**Borough of
New Milford**
Department of Public Works

Re: Addition Block 605 lot 24
729 Stockton Street

This letter is to inform you that your application to for addition on the front of your house at the above address has been denied. The addition violates Borough codes 30-21.4(c)(1), 30-21.5(a) (1) and any other that the Board may deem necessary. Your maximum building coverages is 1,000 square feet and you request is 1,242 square feet. Front yard set back request is 18.2 feet.

**NOTICE OF APPEAL
ZONING BOARD OF ADJUSTMENT
BOROUGH OF NEW MILFORD, BERGEN COUNTY, NJ 07646**

2 PROPOSED SITE PLAN
G-01 SCALE: 1" = 20'-0"

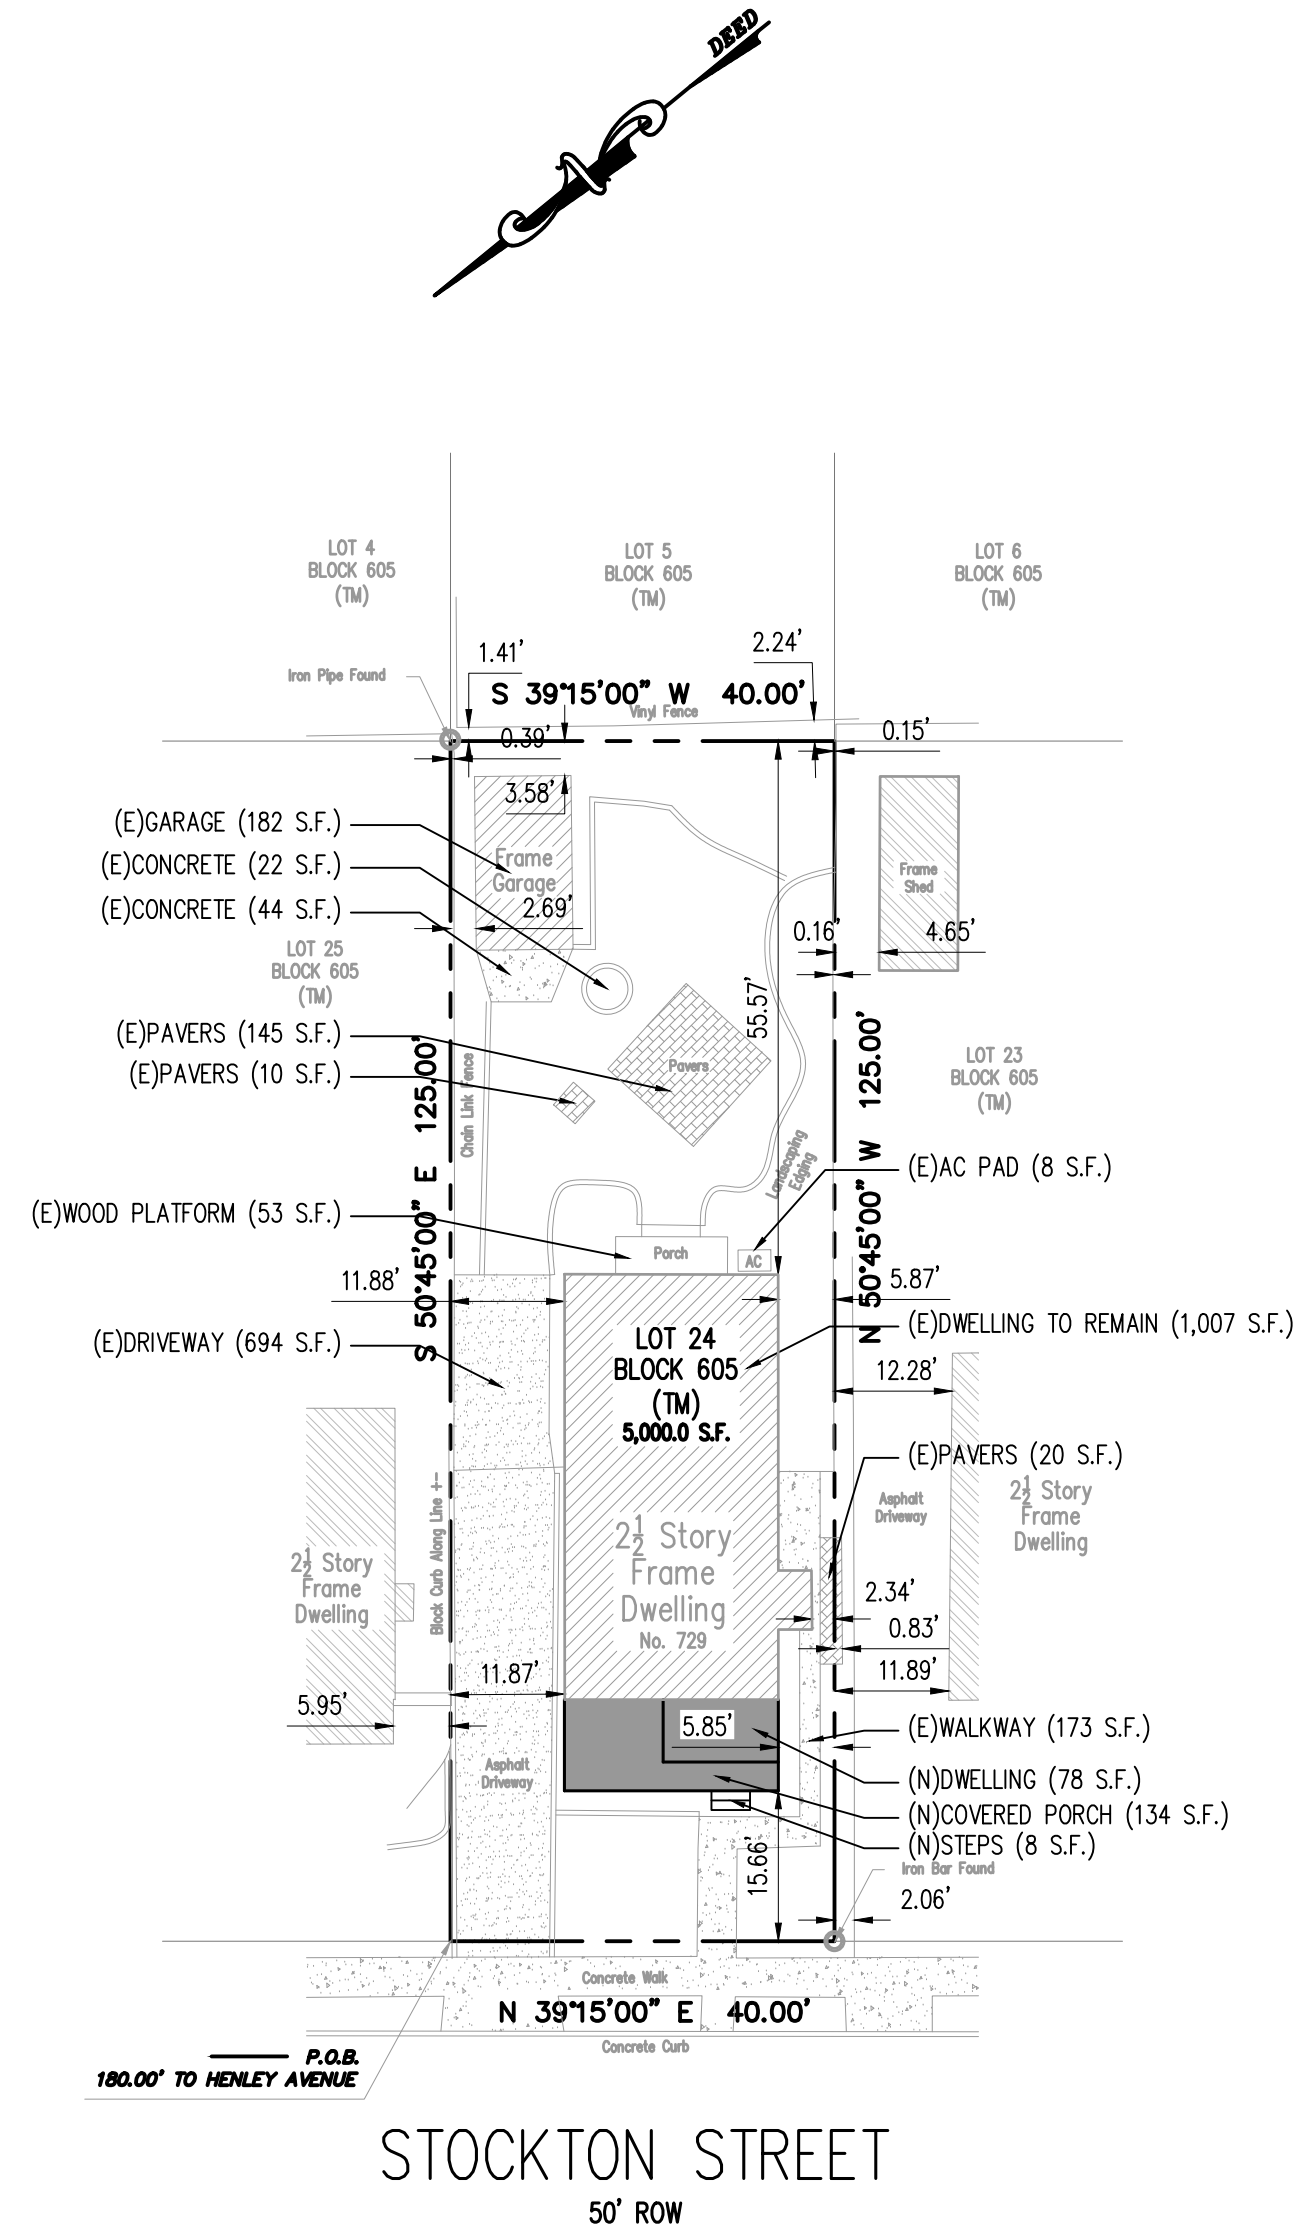
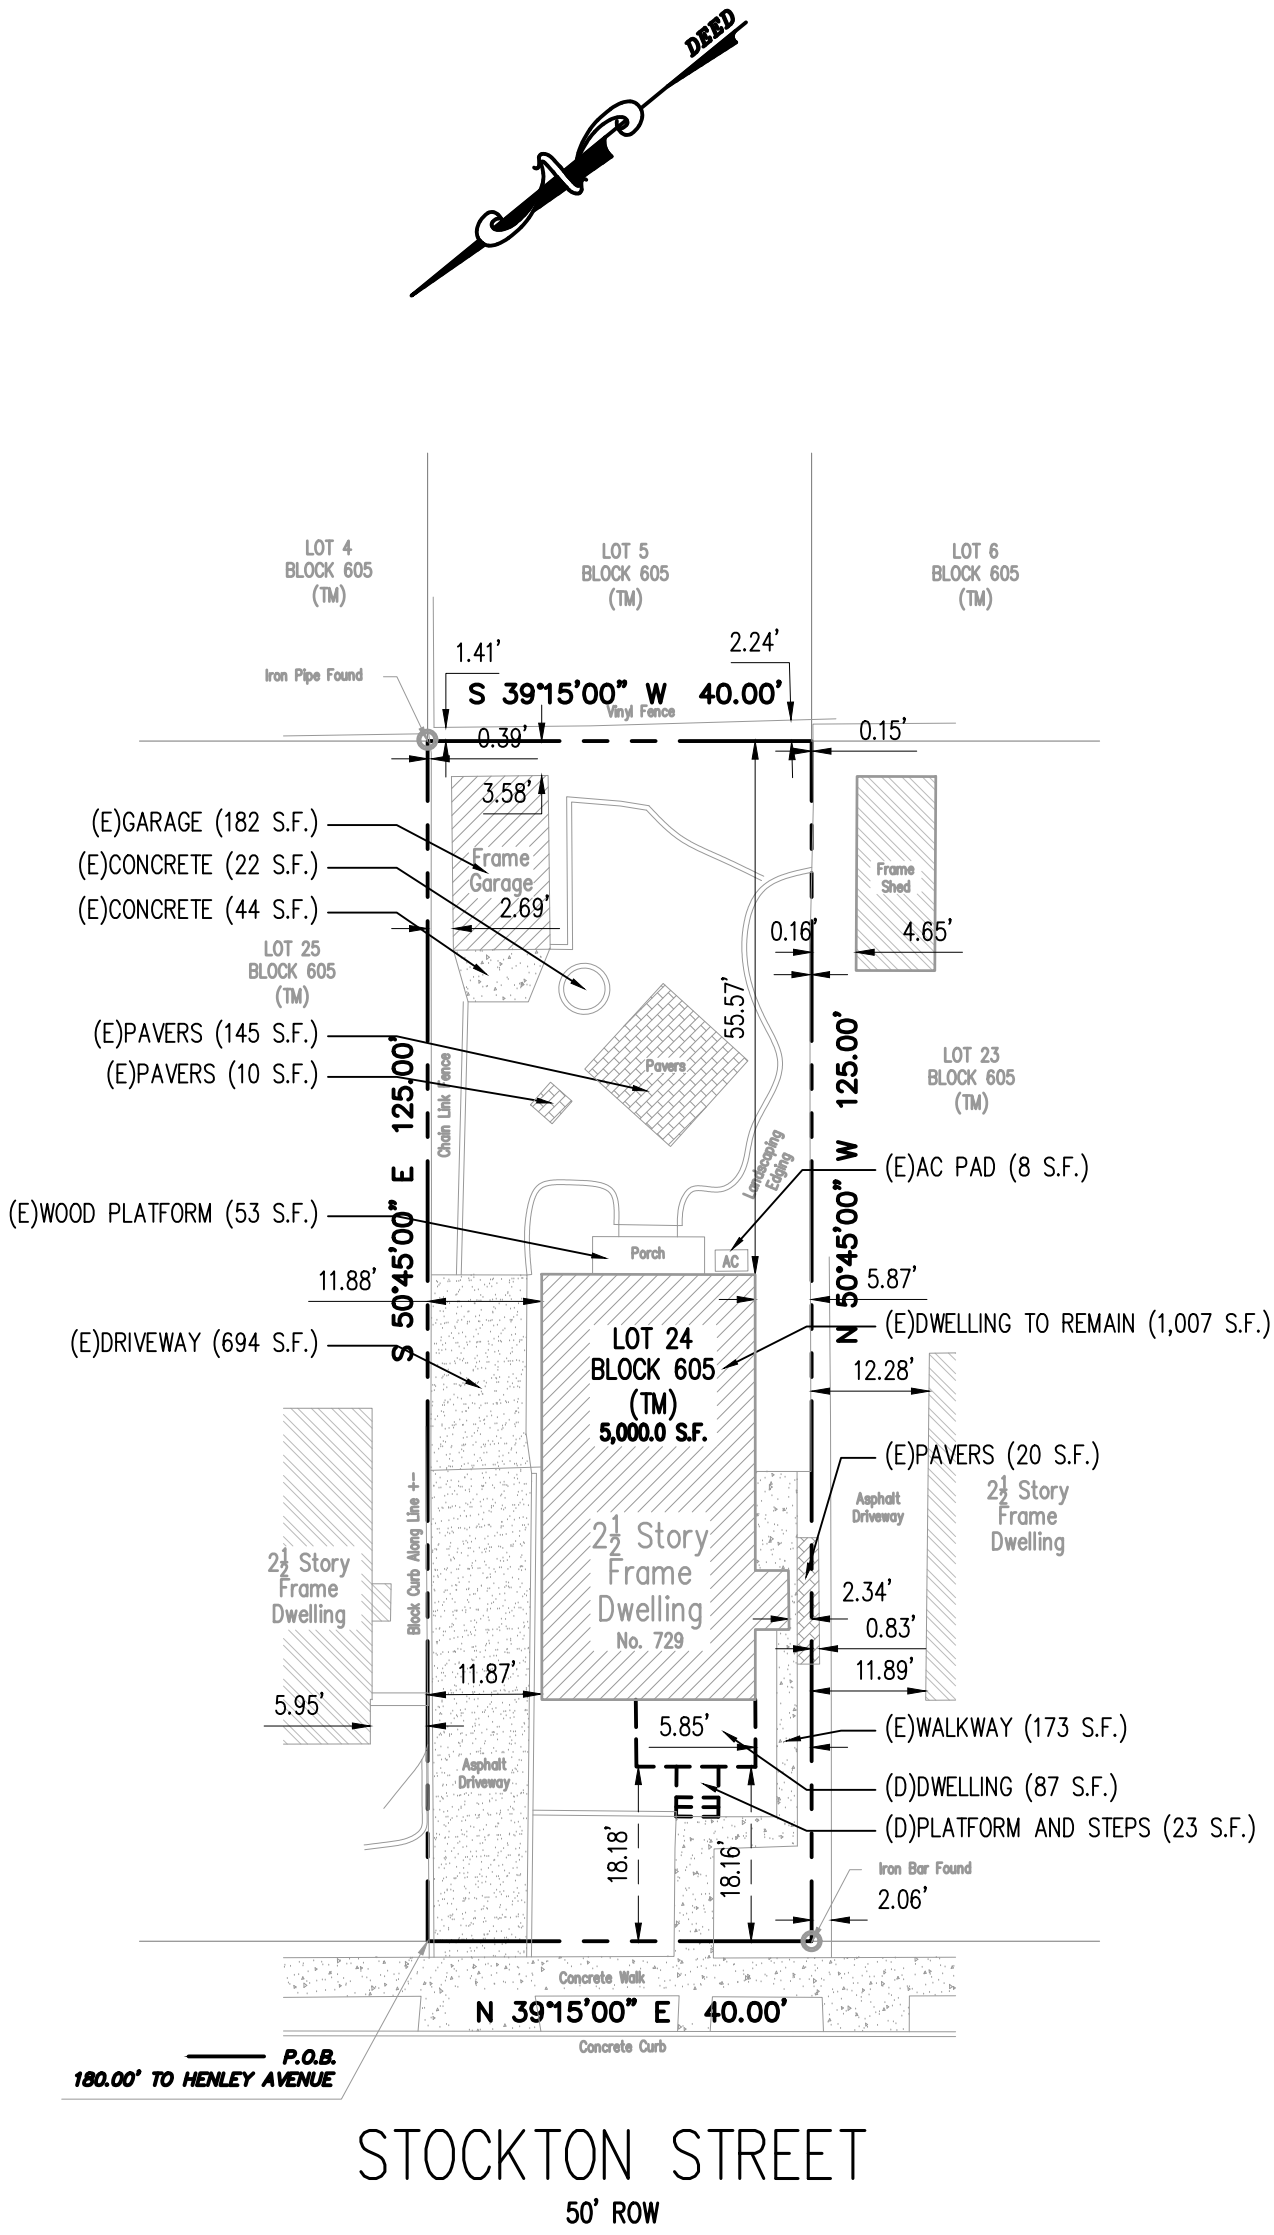
Requirement Avg of Adj. Homes Existing 18.16 Ft Proposed 15.68 Ft to Porch Yes [X] No []
15.68 Ft to House

BUILDING COVERAGE: Required 1000 (A), Proposed: 1401 (11) Yes ☒ No ☐

TOTAL IMPERVIOUS LOT COVERAGE Required 2000 (B), Proposed: 2578 (12) Yes ☒ No ☐

The proposed addition on our home will move the front elevation 2.48 feet closer to the street which is slightly greater than the average on our block. Our existing home covers 1,276 square feet and the proposed addition will cover 125 more square feet, also increasing our impervious lot coverage from 2,468 square feet to 2,578 square feet.
